UNITED STATES PATENT AND TRADEMARK OFFICE

APPLICATION NO.	FILING DATE	FIRST NAMED INVENTOR	ATTORNEY DOCKET NO.	CONFIRMATION NO.
10/631,049	07/28/2003	Christoph Stefan Randazzo	DE03 0210	9286

Office Action Summary

DETAILED ACTION

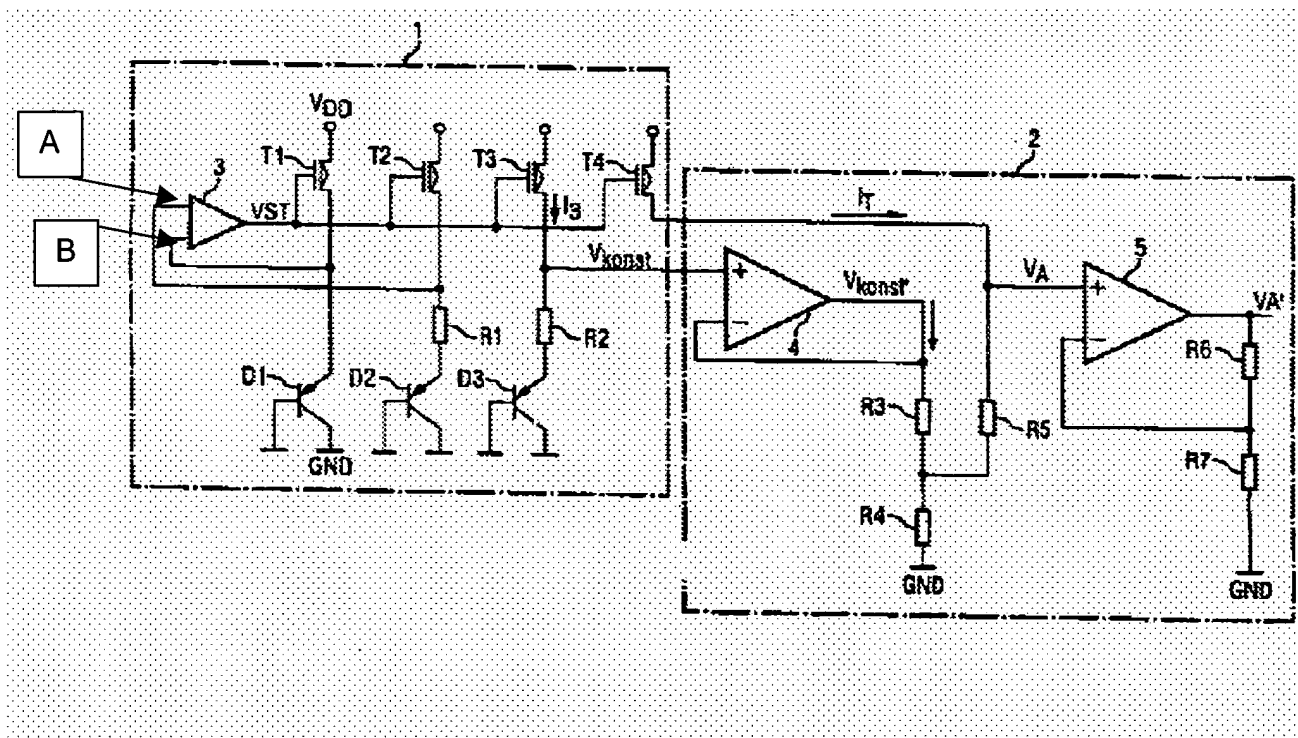
EGERER discloses or suggests all the limitations as claimed by Applicant in Claims 1-4, 9, 10 and 12-18, including an apparatus 1 for performing a temperature measurement function, comprising a first stage with a first circuit (D2, T2; see the Figure, reproduced on next page) and a second circuit (D1, T1) being arranged in parallel, said first circuit comprising a first transistor (T2), a first resistor (R1), and a parallel arrangement of n diodes (D2), said second circuit comprising a second transistor (T1) and a parallel arrangement of m diodes (D1), an operational amplifier (3)

on the input side being connected to the first circuit and the second circuit, said operational amplifier (3) applying a gate voltage to said first transistor (T2) and said second transistor (T1), said apparatus 1, further comprising an output stage (2) with p output transistors (T4), and an output resistor (R5) performing a current to output voltage conversion (V_A) in order to provide an output voltage that depends on the actual temperature as claimed by Applicant in Claim 1.

EGERER further discloses said operational amplifier 3 has a first input (not labeled in EGERER, but annotated "A" in reproduced Figure, above), a second input

(annotated "B" in reproduced Figure, *above*), and an output (VST), the first input (A) being connected to a drain of the first transistor (T2) and the second input (B) being connected to a drain of the second transistor (T1), said output (VST) being connected to a gate of said first transistor (T2) and a gate of said second transistor (T1) for biasing these transistors (T2, T1) as claimed by Applicant in Claim 3.

EGERER further discloses said output stage 2 amplifies said[sic] first current to obtain a third current (I_T) before performing said current to output voltage conversion by converting said third current (I_T) into said output voltage (A) as claimed by Applicant in Claim 4.

EGERER further discloses the gate voltage is applied to gates of the p output transistors (T4) as claimed by Applicant in Claim 13.

EGERER further discloses a temperature compensation network (comprising elements R2 and D3) providing a bandgap reference voltage (V_{KONST}) at another output as claimed by Applicant in Claim 14.
